Re: Sri Venkateswara Temple and Cultural Center
Wetland Review of the Revised Preliminary Site Plan (SP#08-08A)

Sri Venkateswara Temple and Cultural Center (SP#08-08A)
Wetland Review of the Revised Preliminary Site Plan
September 18, 2008
Page 2

Re: Sri Venkateswara Temple and Cultural Center
Woodland Review of the Preliminary Site Plan (SP#08-08A)

PLAN REVIEW CENTER REPORT
September 10, 2008
Revised Preliminary Landscape Review
Sri Venkateswara Temple SP#08-08A

Above: Forested vernal pool wetland not shown on plans, northwest portion
of regulated woodland
Below: Mature bitternut hickory where southwestern parking lot is proposed

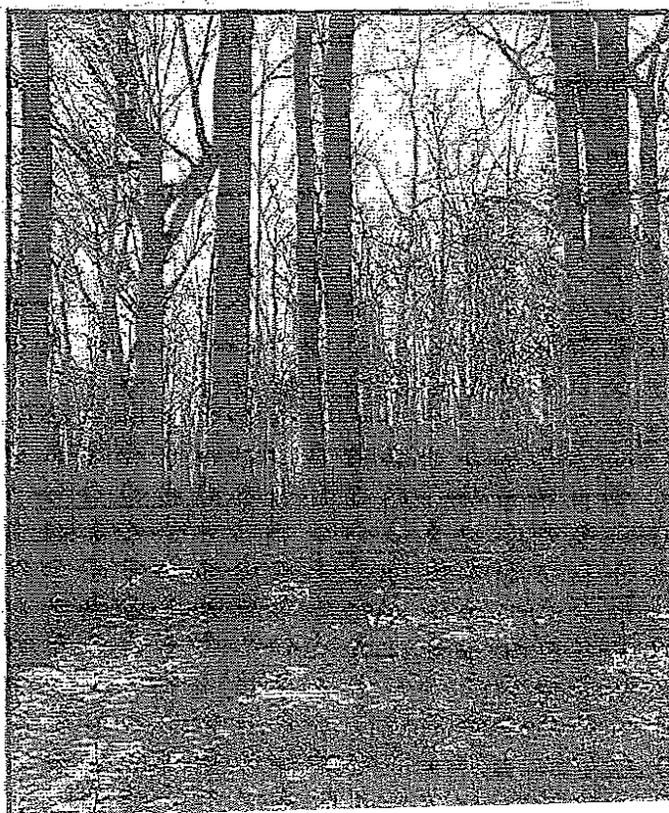
ECT has reviewed the City of Novi Official Woodlands Map and completed an onsite Woodland Evaluation on Wednesday, March 26, 2008. With the exception of an unflagged forested vernal pool area in the northwest portion of the regulated woodland, ECT found that the *Tree Survey/Tree Removal Plan* (Sheet 3) accurately depicts existing site conditions. The surveyed trees have been marked with the survey numbers in yellow paint. Numerous mature hardwood trees exceeding 20 inches in dbh occur scattered throughout the regulated woodland where the temple and priest housing (Phases 1 and 2) and associated parking are proposed, including sugar maple (*Acer saccharum*), red maple (*Acer rubrum*), black walnut (*Juglans nigra*), bitternut hickory (*Carya cordiformis*), and tuliptree (*Liriodendron tulipifera*). The site showed evidence of disturbance, with soil spoil piles, brush heaps, and debris piles located near the transition between old field and regulated woodland and mature black locusts (*Robinia pseudoacacia*) scattered throughout the regulated woodland. See attached site photographs.

Above: Mature sugar maple where southwestern parking lot is proposed

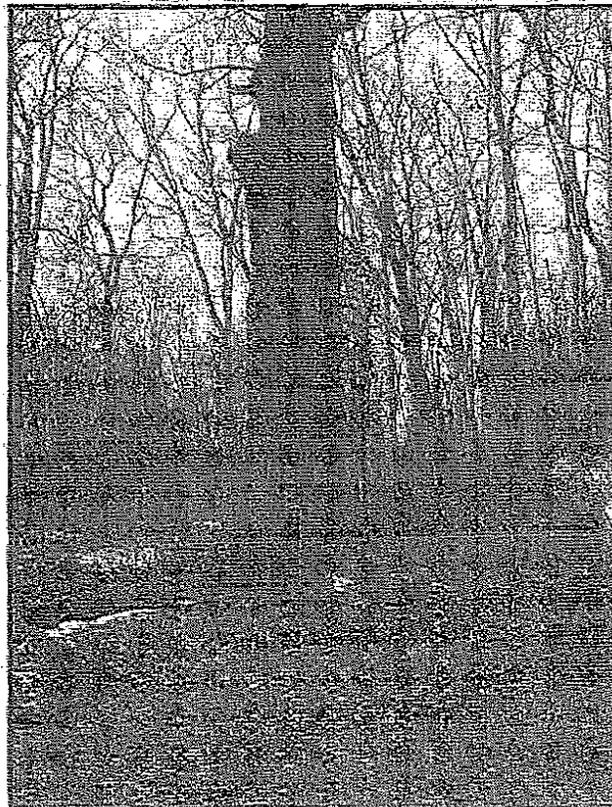
Below: Mature northern red oak to be saved, west end
